# MaxFlight

## SERVICE BULLETIN

To  
Fax  
Company  
Subject: MaxFlight Safety Service Bulletin 2008-001  
Sent: 4/13/08 at 8:30:00 PM

### Mandatory Service Bulletin # 122004

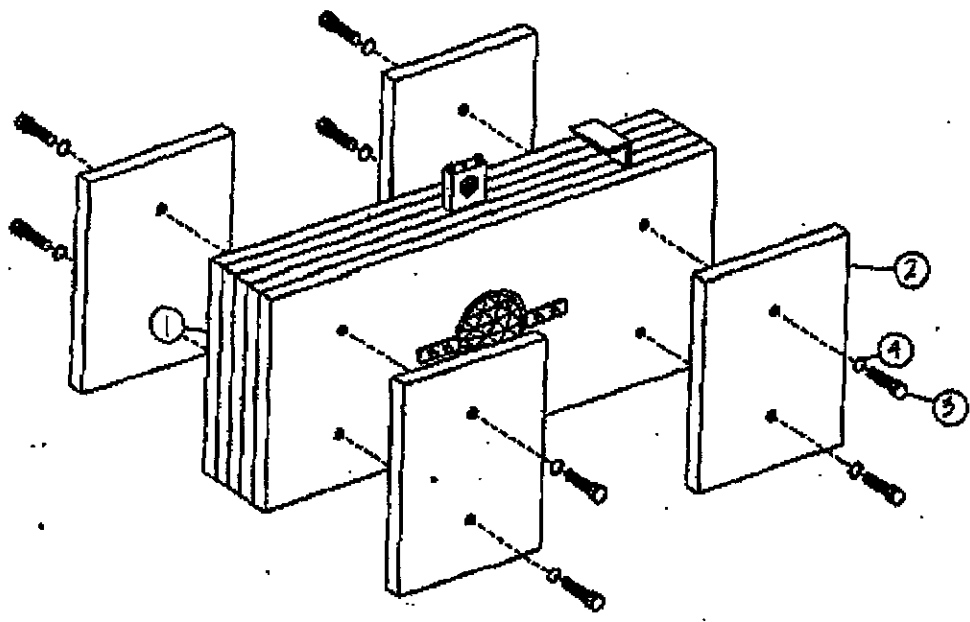
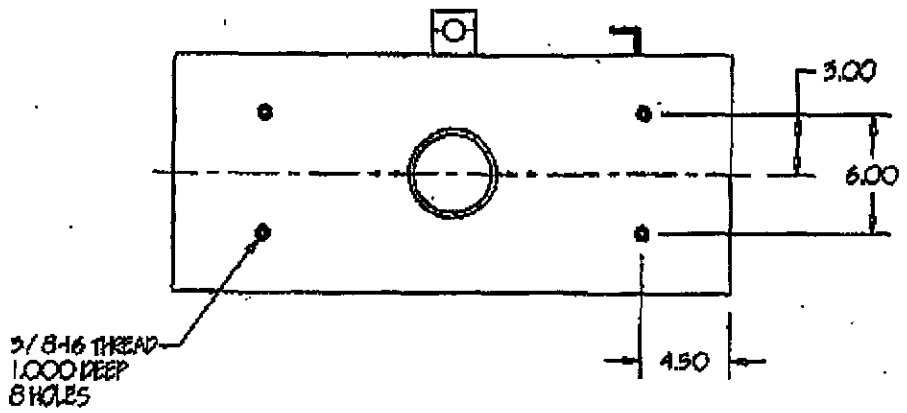
- Locate the two set screws on the pitch encoder collar, remove and re-install using Blue Loc-Tite and ensure that the screws are tightened firmly.
- Locate the one set screw on the roll motor encoder shaft collar, remove and re-install using Blue Loc-Tite and ensure that the screw is tightened firmly.

We have made it a weekly requirement to inspect both encoders for security and set screws for tightness. Please add this requirement to your present weekly inspection.

Drawing 1

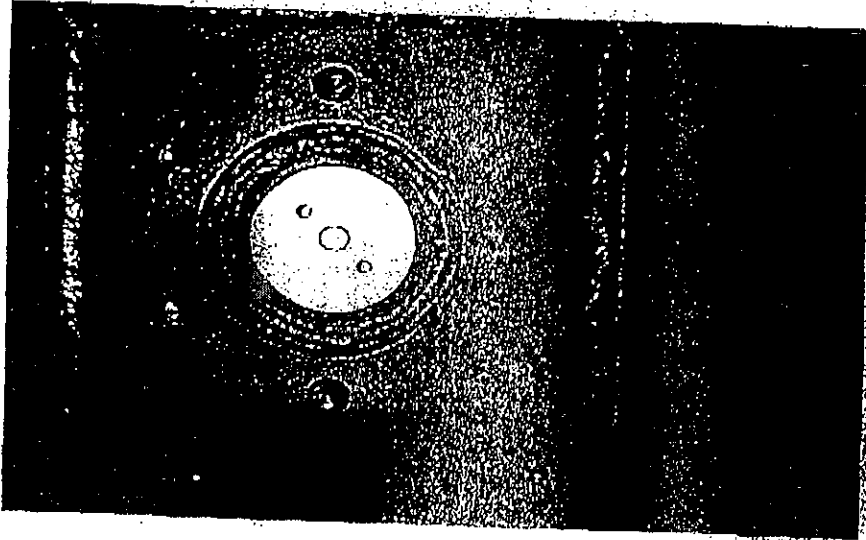
10. Use a  $\frac{1}{4}$ "-13 tap and thread the end of the Counterweight Shaft.
11. Install the threaded rod through the counterweight shaft leaving the grooved end of this rod exposed 1" out of the support frame as per Drawing 1.

Drawing 4

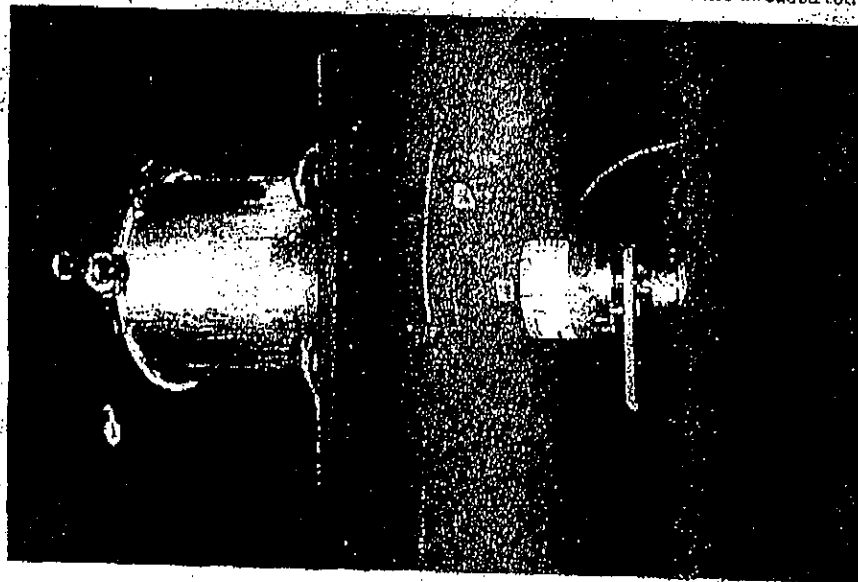
- 13. Reinstall the roll encoder. Do this now because clearance is very limited.
- 14. Thread the remaining exposed rod into the counterweight until it is flush with the support frame as per Drawing 4. Use Blue Loctite to secure.

Item	Qty.	Description (Part Number)
Parts List		
TITLE: Crotch Belt Lower Buckle Mount Hinge		
MAXFLIGHT CORPORATION 1 Executive Drive Toms River, NJ 08755 1-732-281-2007 FAX 1-732-281-0209		
P.N.	DWG SBI22004-2	
Scale:	None	DRAWN BY: WVB
Mat:	DATE: 30 Nov 2004	REV
APPROVED BY:

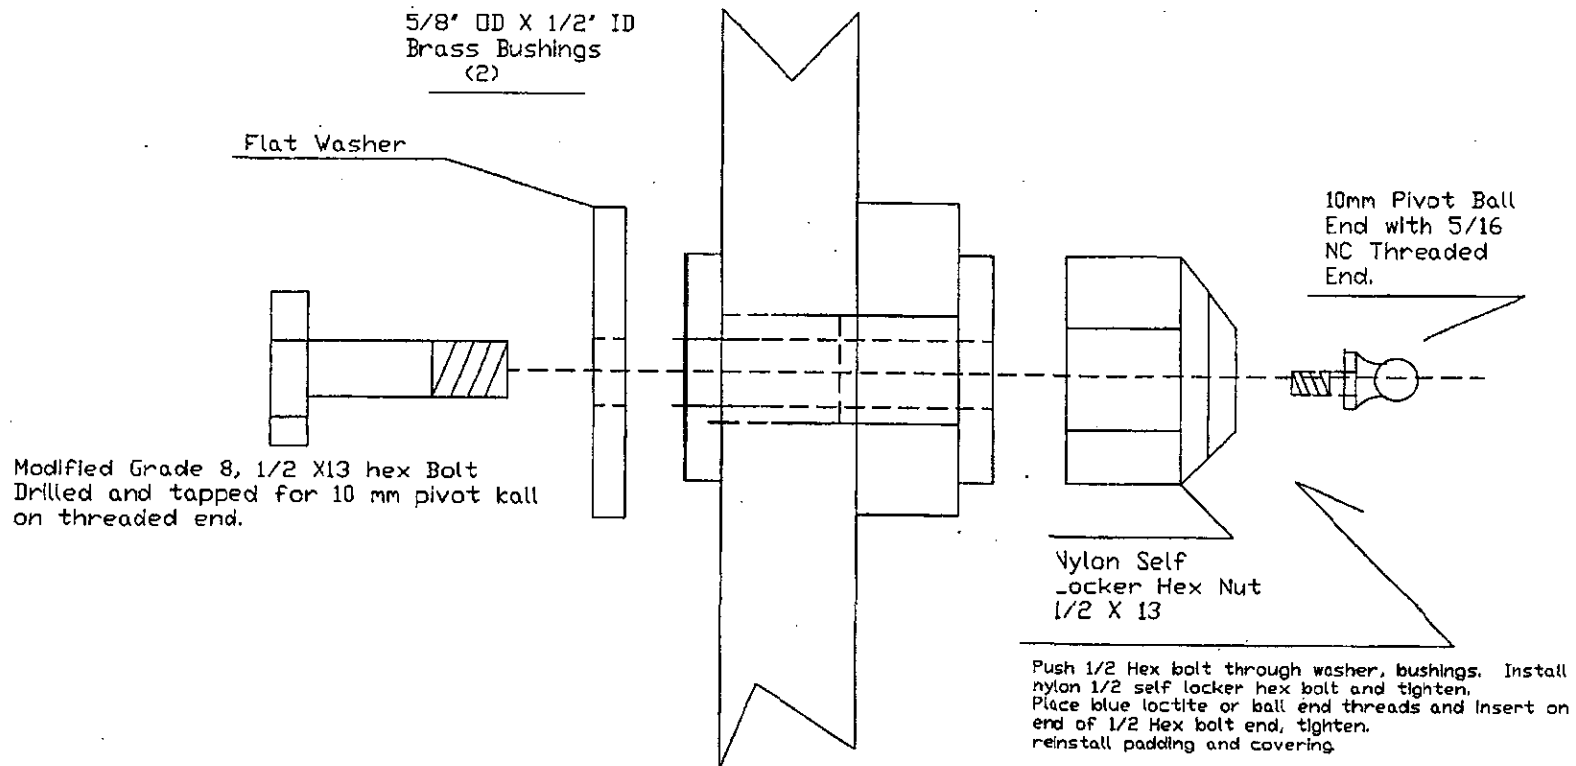
On systems that were modified with brass bushings, verify that bushings are in good shape before installing new bolt and pivot ball assembly.

On systems that were never modified and have the original 1/2" hole through shoulder restraint, verify hole and shoulder restraint is in good condition before installing new pivot ball assembly.

DOCUMENT NUMBER SB122004-4

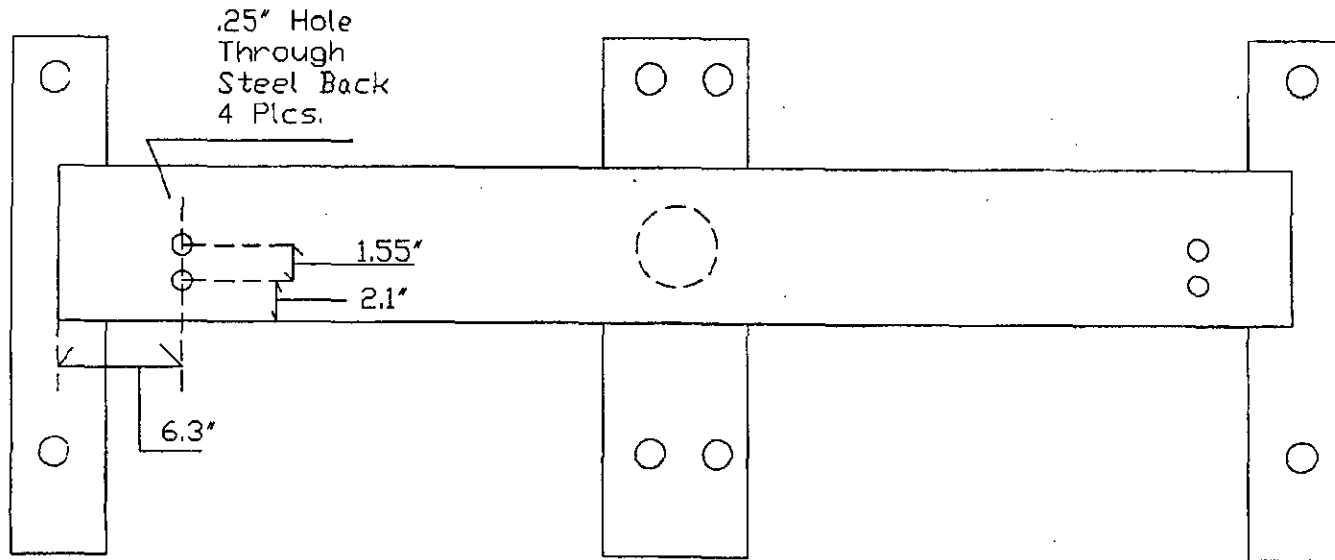
18. Repeat 14-18 on other side of the machine. (If Required)
19. Locate the drawing # SB122004-4, this shows the location of holes to be drilled on lower cross tube of shoulder restraint.

20. Measure, mark and drill left side bolt hole first on cross tubes, place hold bar in place with bolt and nut according to drawing. Holding bar parallel, drill second hole through tube using bar as guide.

Item	Qty.	Description (Part Number)
Parts List		
TITLE: Hinge location drawing		
MAXFLIGHT CORPORATION 1 Executive Drive Toms River, NJ 08755 1-732-281-2007 FAX 1-732-281-0209		
P.N.		DWG: SB122004-10
Scaler: None		DRAWN BY: WVB
Mettl		DATE: 30 Nov 2004
APPROVED BY:		REV
		DATE:

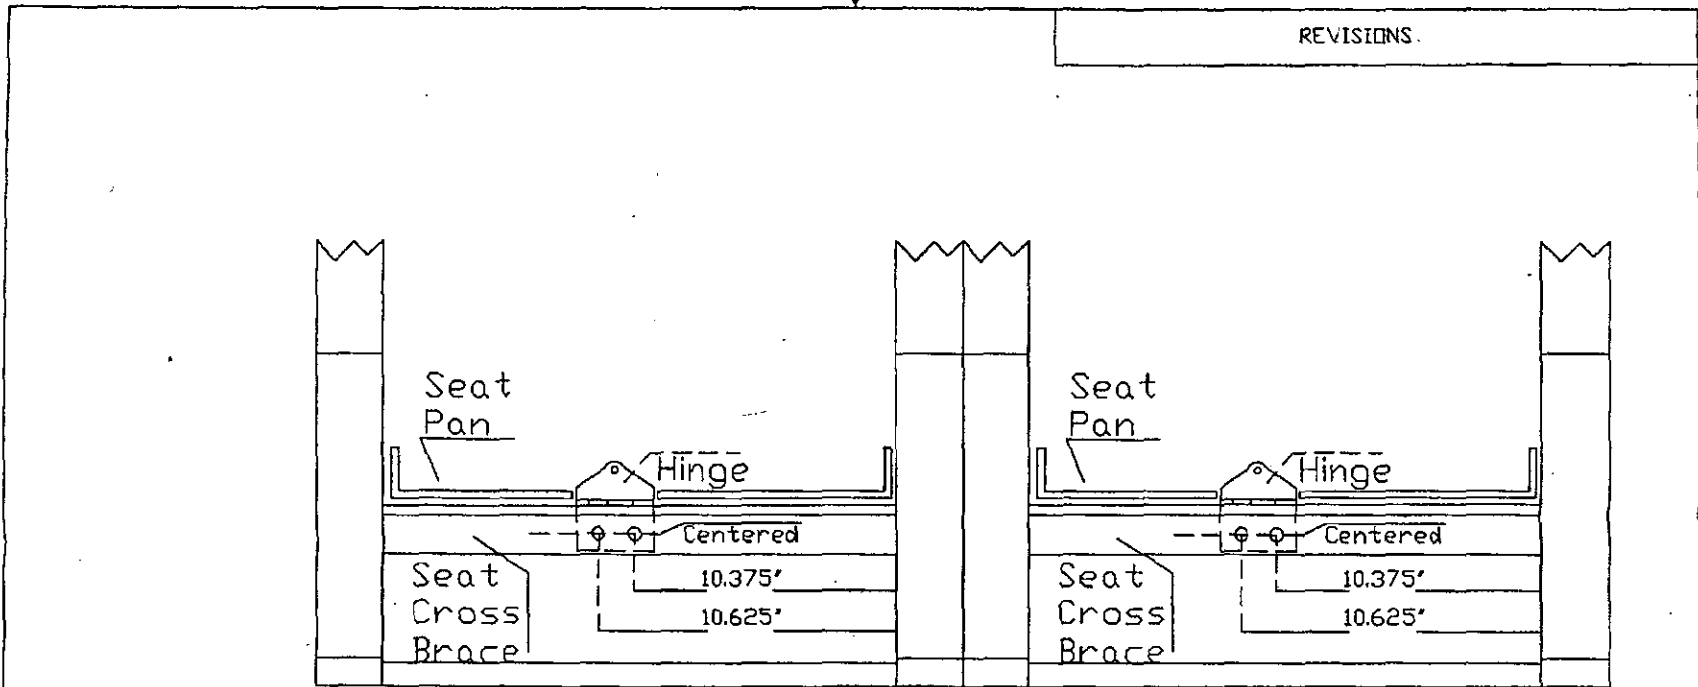
33. Remove seat pan if installed and modify same as per drawing # SB122004-8.
34. Reinstall seat pan after modification.
35. Using drawing # SB122004-10, measure, mark and drill holes for the hinge that will mount to the lower front seat cross bar.
